File No. 16.01.292

September 12, 2019

**ADDENDUM NO. 1
SOUTHERN HEIGHTS AND COURTRIGHT
RETAINING WALL DESIGN**

Enclosure: Conceptual Design Plan

Conceptual Design 9/12/19

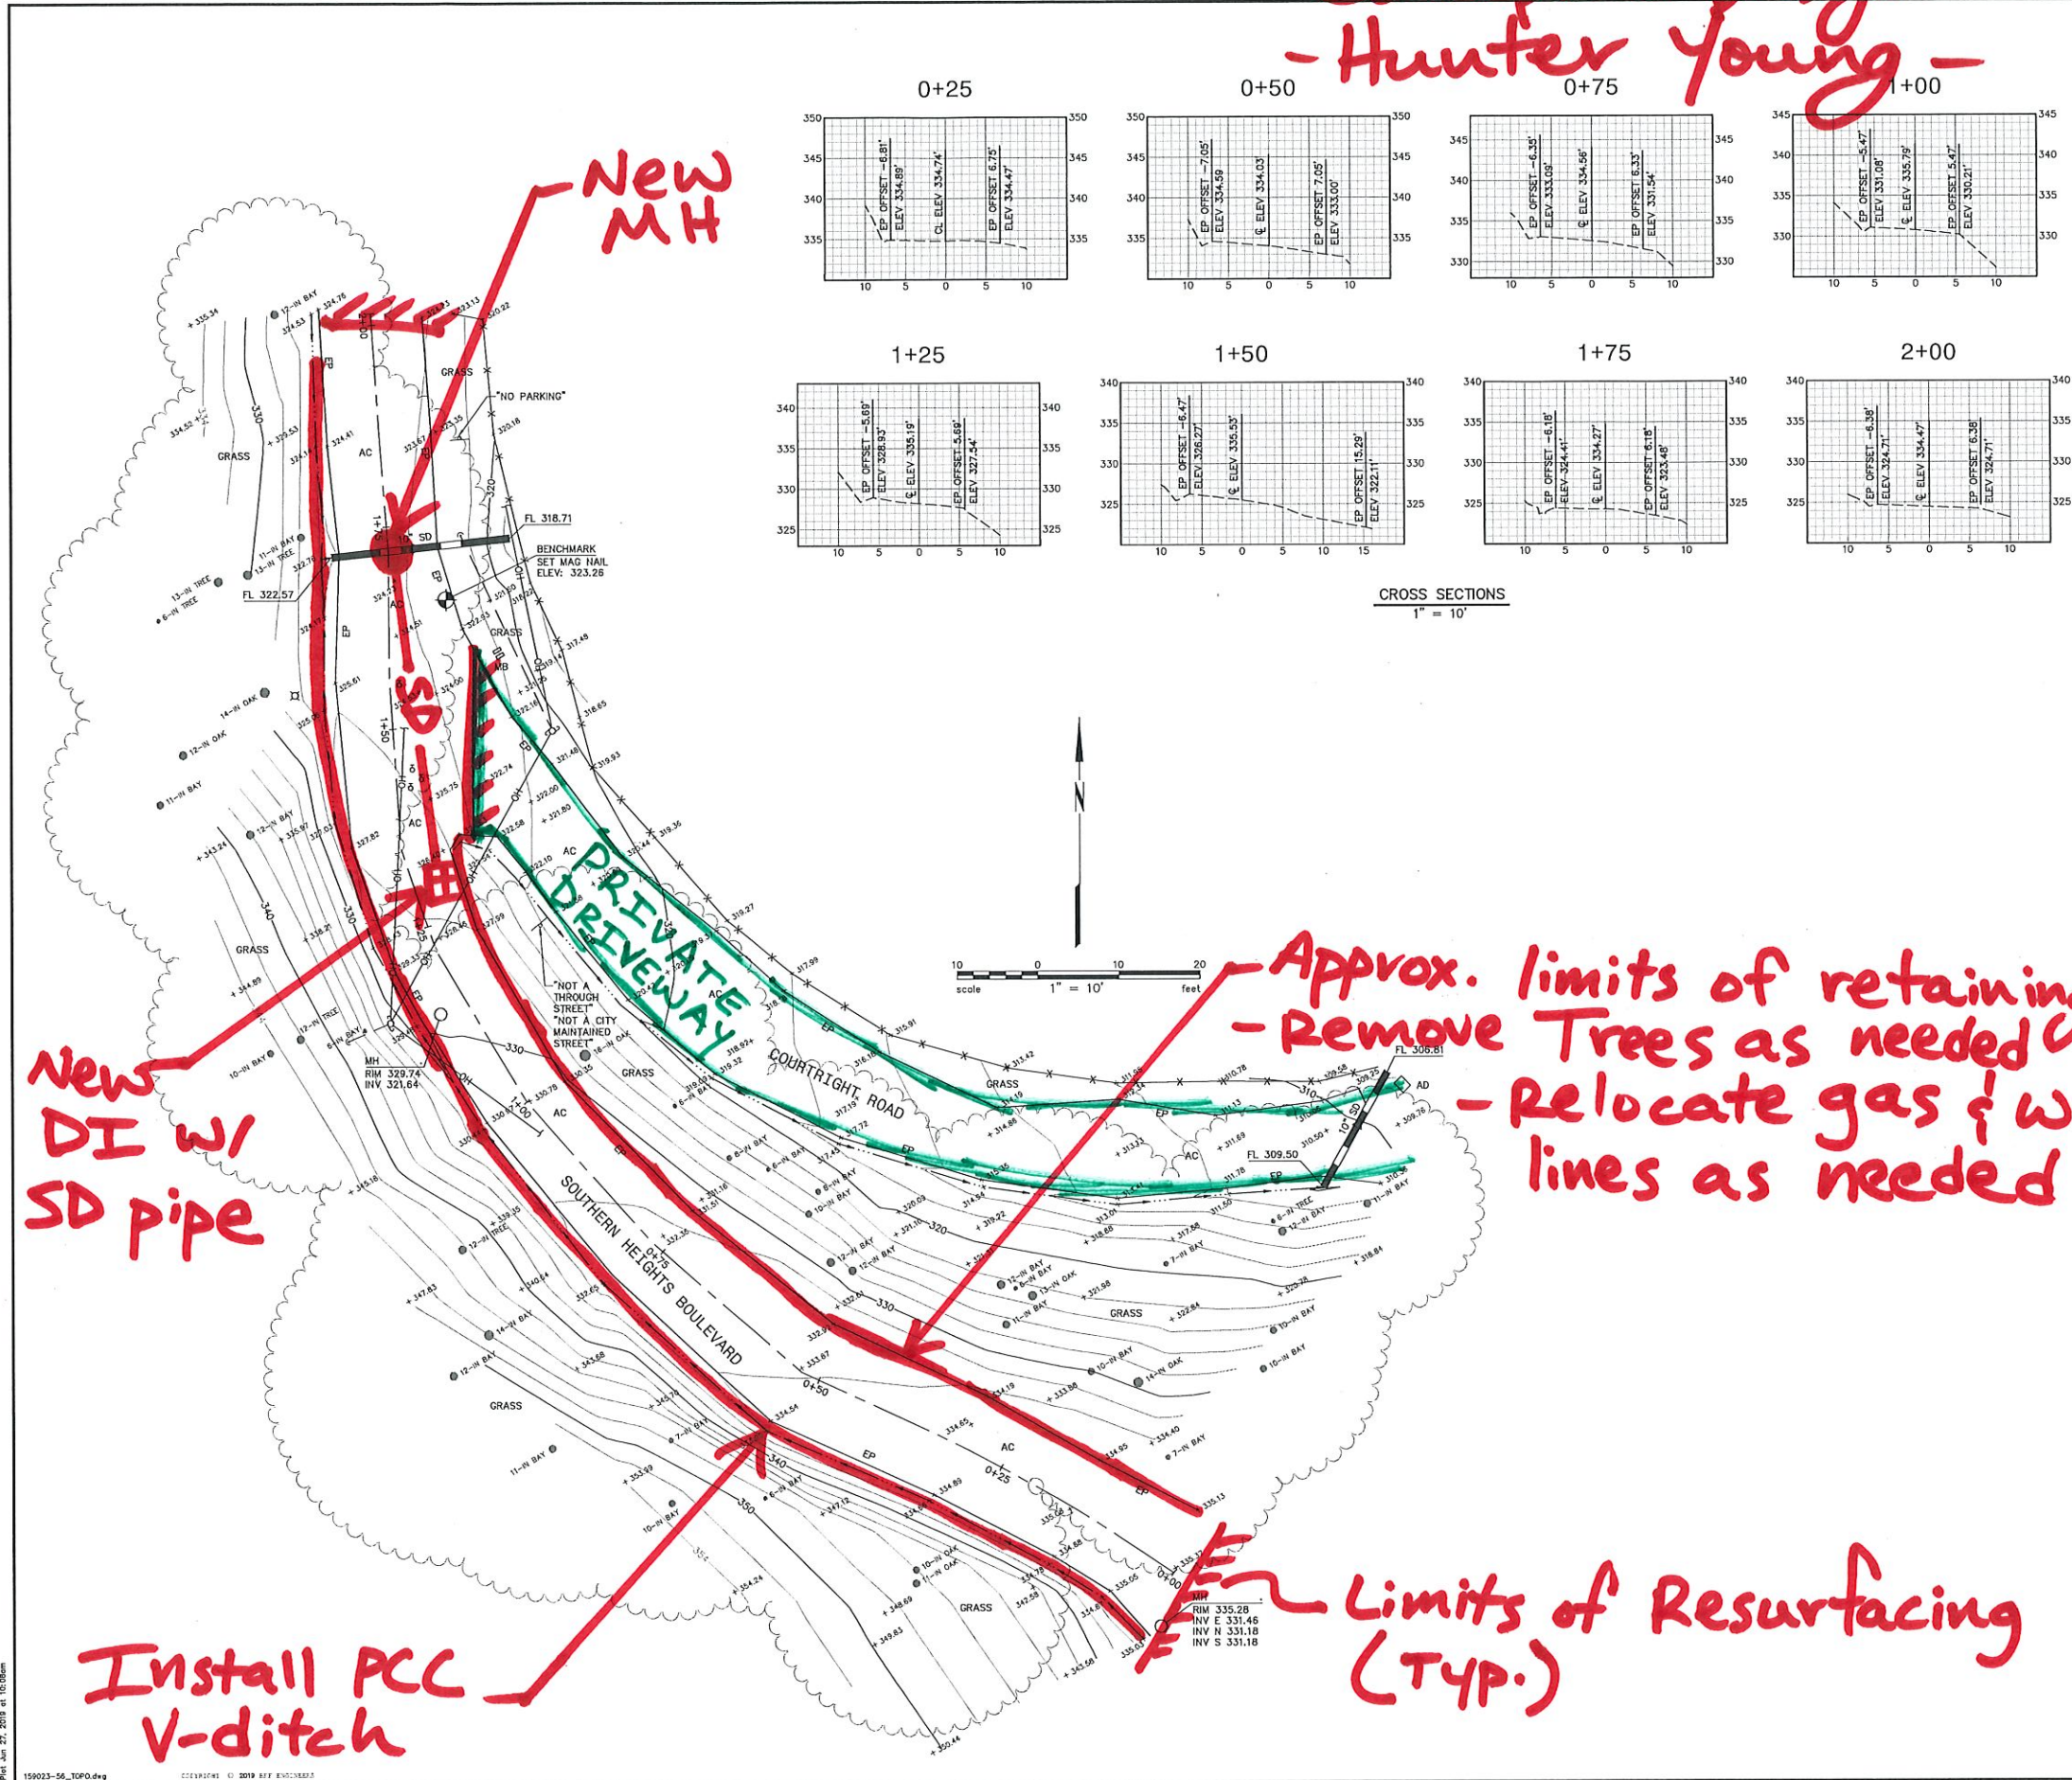
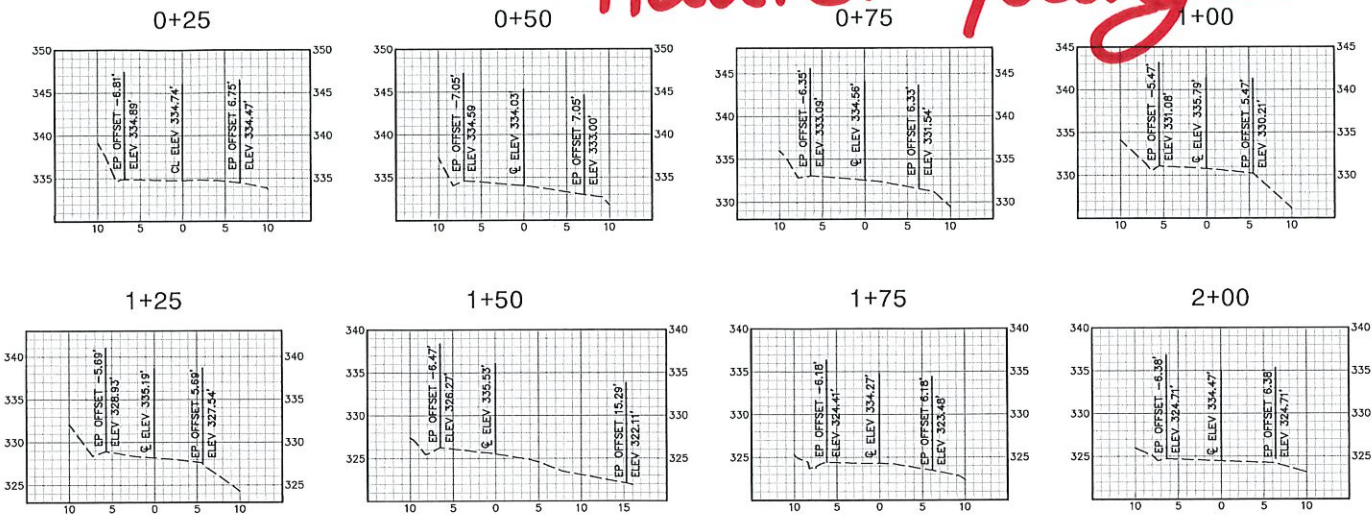
Please find enclosed with this addendum a conceptual design plan outlining the intent and scope of work related to this project. The design consultant will need to perform all elements of the design, or retain subconsultants as necessary, such that a single set of construction drawings can be advertised including, but not limited to, storm drain, resurfacing, concrete V-ditch, clearing and grubbing, utility coordination, and the retaining wall. Any other work not specifically identified on the enclosed conceptual design plan, but which is necessary in order to prosecute the work, is included in this Request for Proposals. Proposers should note that no work on the private driveway is included as part of the City's project.

New DI w/ SD pipe

New MH

Approx. limits of retaining wall
- Remove Trees as needed
- Relocate gas & water lines as needed

Install PCC V-ditch

Limits of Resurfacing (Typ.)
